STAFF RECOMMENDATION

916 Boscobel Street

August 17, 2016

Application: New construction—detached accessory dwelling unit; Setback determination

SITE PLAN

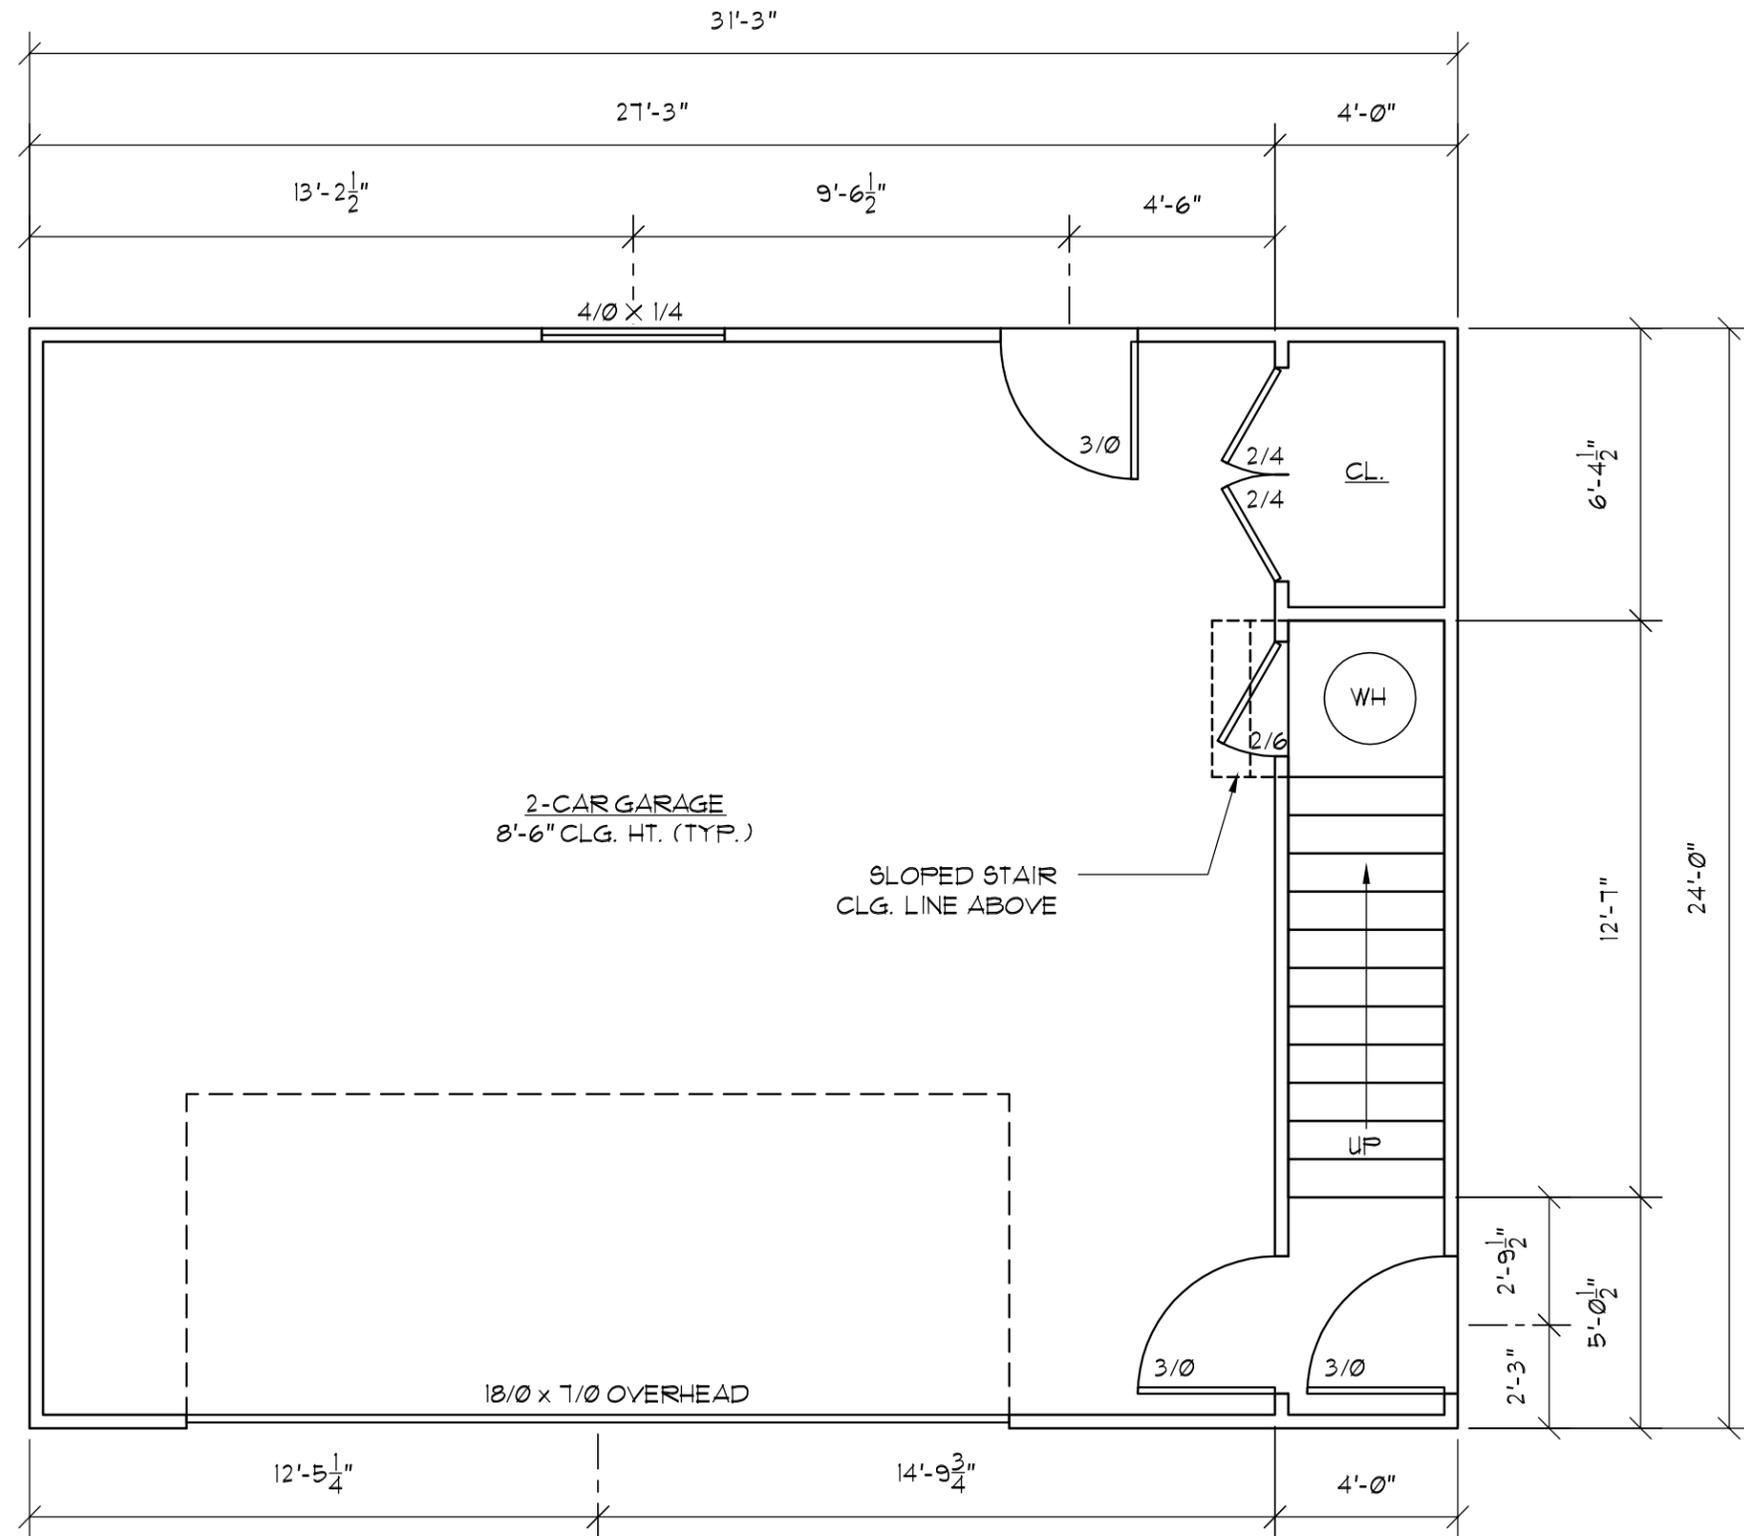
MINIMUM	PROPOSED
Building located towards rear of lot	n/a	Yes
Space between principal building and DADU/Garage	20'	48'
Rear setback	20'	10'
L side setback**	3'	12'9"
R side setback**	3'	5'
How is the building accessed?	From the alley or existing curb cut	Alley

The new DADU does require a rear setback determination. When an outbuilding has a footprint greater than seven hundred square feet (700 sq. ft.), base zoning requires that the structure be located twenty feet (20') from the rear property line and five feet (5') from the side property lines. In this instance, the structure is located at least five feet (5') from the side property lines, but it is located ten feet (10') from the rear property line. Staff finds that the proposed rear setback is appropriate because a ten foot (10') setback is the standard rear setback for structures that are seven hundred square feet (700 sq. ft.) or less. Also, historically, outbuildings were located at the rear of the property, close to the rear property line. A ten foot (10') rear setback is more historically appropriate than a twenty foot (20') rear setback. In addition, the ten foot (10') rear setback allows for more space between the primary structure and the outbuilding. Staff recommends approval of the setback determination.

The project meets Sections III.B.2.a. and III.B.2.h. of the design guidelines and 17.16.30.G. 4 of the ordinance.

01 FIRST FLOOR PLAN
 750 SQ. FT.

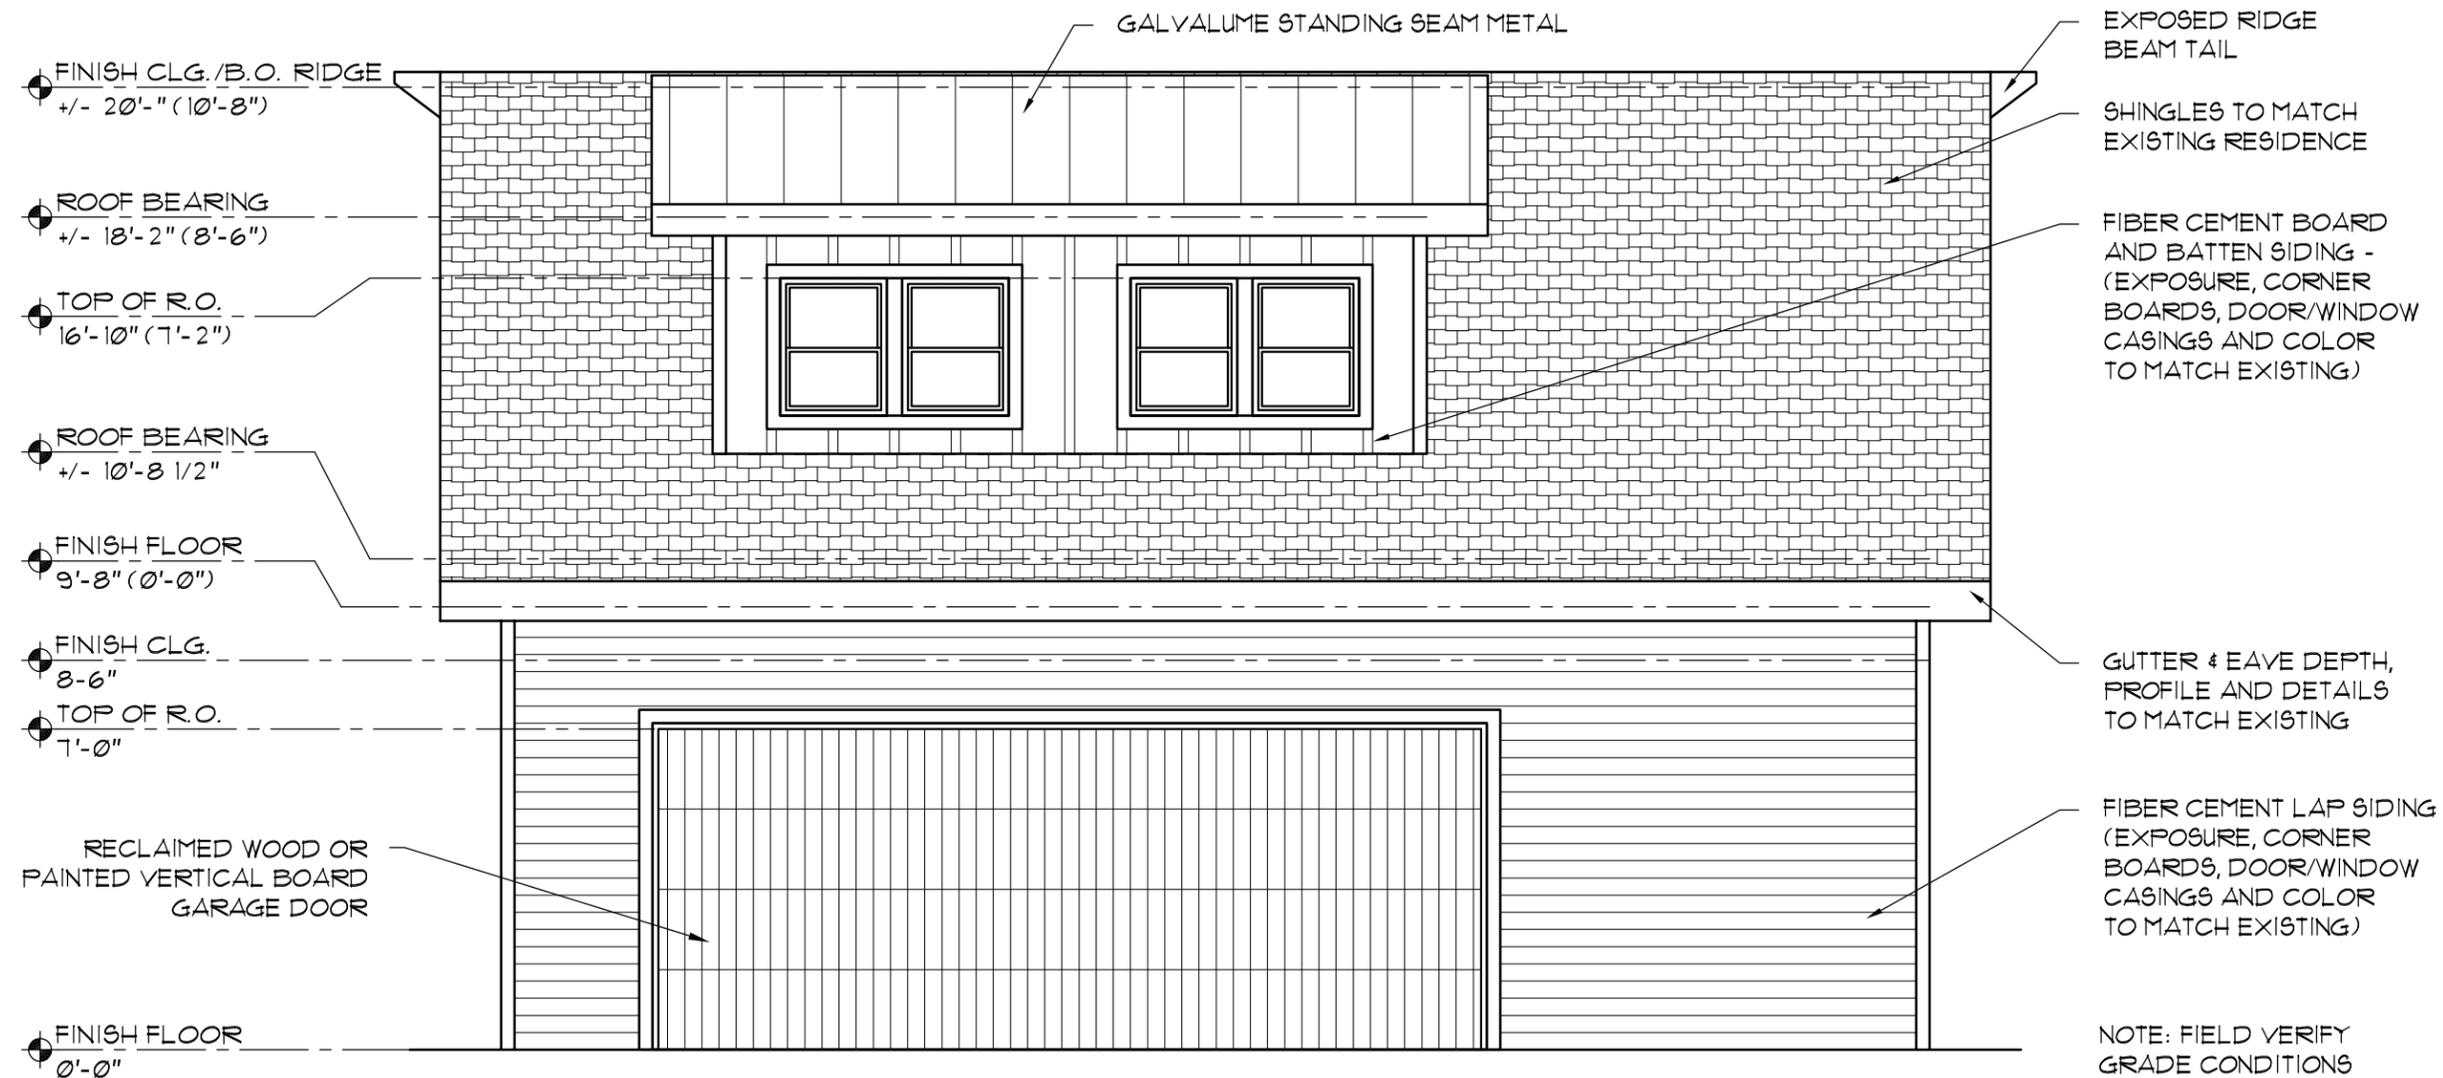
Lot is less than 10,000 square feet	50% of first floor area of principle structure	Proposed footprint
Maximum Square Footage	750 sq. ft.	949 sq. ft.	750 sq. ft.

The project meets Section III.B.2.h. of the design guidelines and 17.16.30.G. 7 of the ordinance.
